Product Change Notice (PCN)

PCN Number: **PCN-0451528R-01**

Product(s) Affected: **PJ-064X**

Reason(s) for Change: **Factory Location Change.**

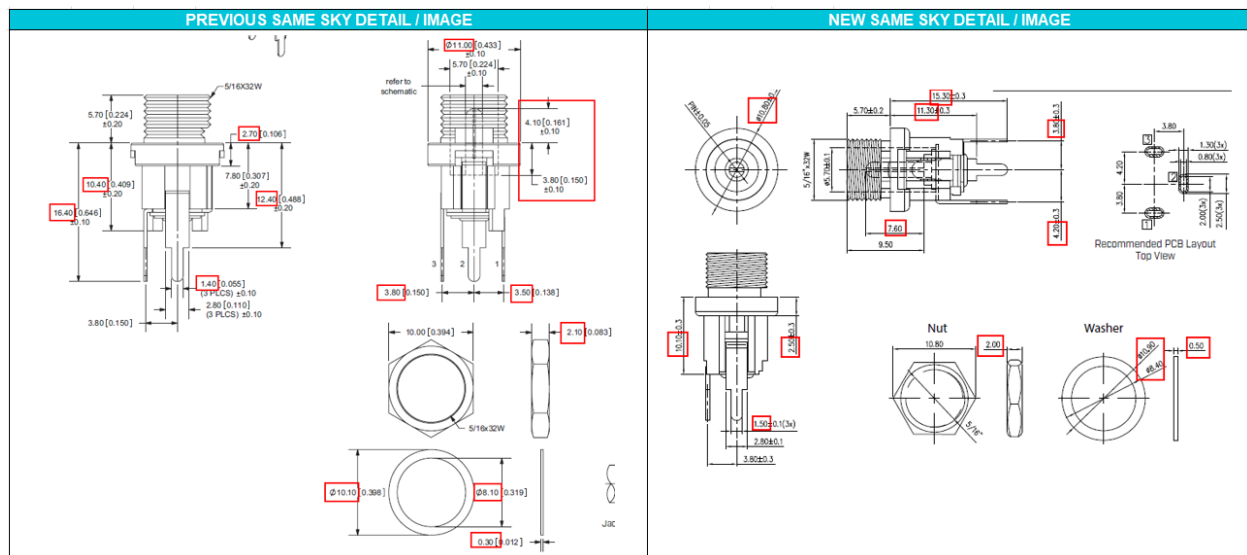
Description of Change: **Mechanical, material and electrical differences as shown in the detail image below.**

MATING PLUG
Jack Insertion Depth: 8.4mm

MATING PLUG
Jack Insertion Depth: 9.5 mm

MATERIAL	PLATING
center pin	brass	nickel
terminal 1	brass	silver
terminal 2	phosphor bronze	silver
terminal 3	brass	silver
bushing	brass	nickel
insulator	red vulcanite fiber	
plastic	PBT	
nut	brass	nickel
washer	steel	nickel

DESCRIPTION	MATERIAL	PLATING/COLOR
center pin	brass	CuSn
terminal 1	C2680R ±0.40 mm	silver
terminal 2	C5210R ±0.50 mm	silver
terminal 3	C2680R ±0.40 mm	silver
bushing	brass	nickel
insulator	bakelite	---
housing	PBT (UL94V-0)	black
nut	brass	nickel
washer	SPCC	nickel
